OFFICE OF NEW REACTORS
SUMMARY FEEDBACK ON FOUR KEY LICENSING ISSUES
NEXT GENERATION NUCLEAR PLANT
PROJECT 0748

RESPONSES TO SPECIFIC REQUESTS FOR NRC FEEDBACK

Figure 1. NGNP Frequency-Consequence curve proposed by DOE/INL (ML12262A090)

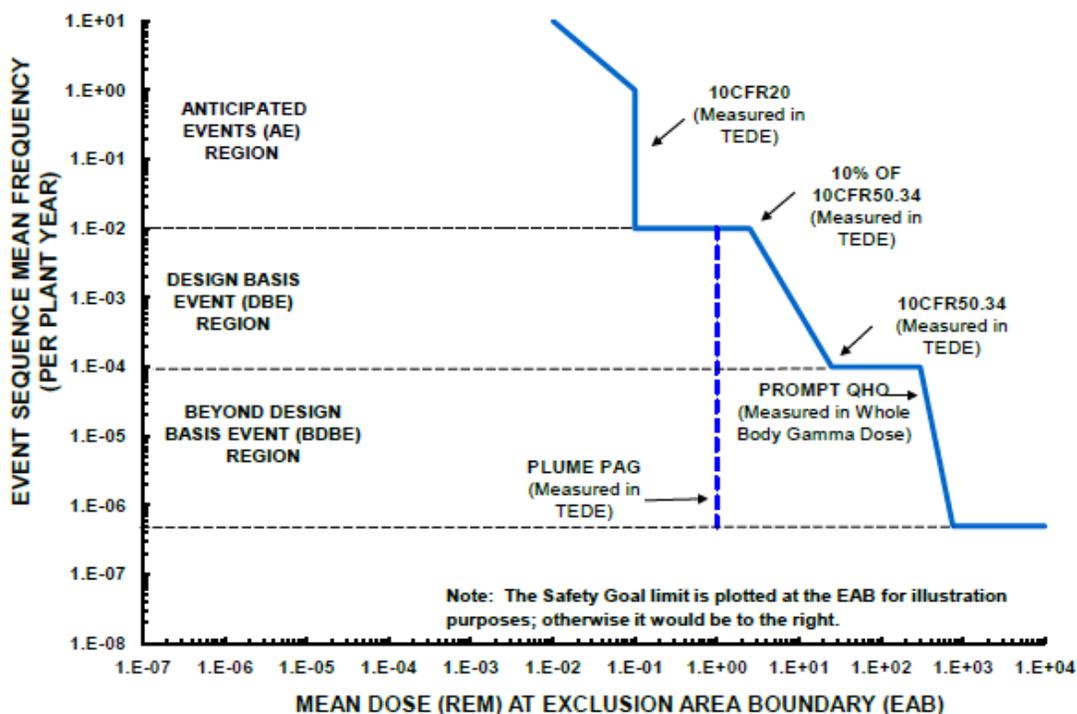
The NRC staff concludes that the proposed approach to placing top level regulatory criteria (TLRC) on a frequency-consequence (F-C) curve is reasonable. Figure 1, a copy of DOE/INL's proposed F-C curve, identifies the regulatory bases for the respective TLRC and displays the TLRC-based dose limits as a function of event sequence mean frequency over the proposed event category regions.

The proposed FC-curve's event category regions and their respective TLRC bases are summarized as follows:

- The TLRC for the AE region would be based on limiting the annual dose to an individual member of the public to 100 millirem total effective dose equivalent (TEDE) as required in 10 CFR Part 20, "Standards for Protection against Radiation." DOE/INL proposes that AE source terms should be mechanistically modeled and that dose consequences should be realistically calculated at the exclusion area boundary (EAB).

- The TLRC for the DBE region would be based on an event-based public dose criterion of 25 rem TEDE as required in 10 CFR 50.34, "Contents of Applications; Technical Information."⁷ DOE/INL proposes that DBE source terms should be mechanistically modeled and that dose consequences should be conservatively calculated at the EAB.

- The TLRC for the BDBE region would be based on cumulative public dose limits derived from the quantitative health objectives (QHOs) of the NRC safety goals, whereby the QHO for prompt fatality is the most limiting. DOE/INL proposes that BDBE source terms should be mechanistically modeled and that offsite dose consequences should be realistically calculated.

The NRC staff concludes that DOE/INL's proposed frequency cutoffs are reasonable for use in the proposed context of modular HTGR licensing. Although DOE/INL states that the proposed F-C curve with its associated frequency cutoffs is intended to be technology neutral, the staff

DOE/INL defines DBEs as having sequence frequencies between 1×10^{-2} and 1×10^{-4} per plant-year. The staff believes this lower frequency cutoff is reasonable as long as the PRA used in the LBE selection process assesses multiple failures from common-cause events and as long as it accounts for both operating and shutdown modes and internal and external plant hazards.

DOE/INL defines BDBEs as having sequence frequencies between 1×10^{-4} and 5×10^{-7} per plant-year. The QHO of the prompt fatality safety goal in NUREG-0880, "Safety Goals for Nuclear Power Plants: A Discussion Paper," issued February 1982, limits the increase in an individual's annual risk of accidental death to 0.1 percent of 5×10^{-4} per year or an incremental increase of 5×10^{-7} per year. Consistent with this QHO, the NRC staff concludes that the lower frequency cutoff for the BDBE region of 5×10^{-7} per plant-year is reasonable.

DOE/INL further proposes that the PRA should consider event sequences down to 1×10^{-8} per plant-year to ensure that there are no any "cliff-edge" sequences that could result in high dose consequence below the BDBE cutoff of 5×10^{-7} per plant-year. This proposal is likewise reasonable. However, the staff notes that the regulatory treatment of these lower cutoff frequencies will likely require consideration by the Commission.
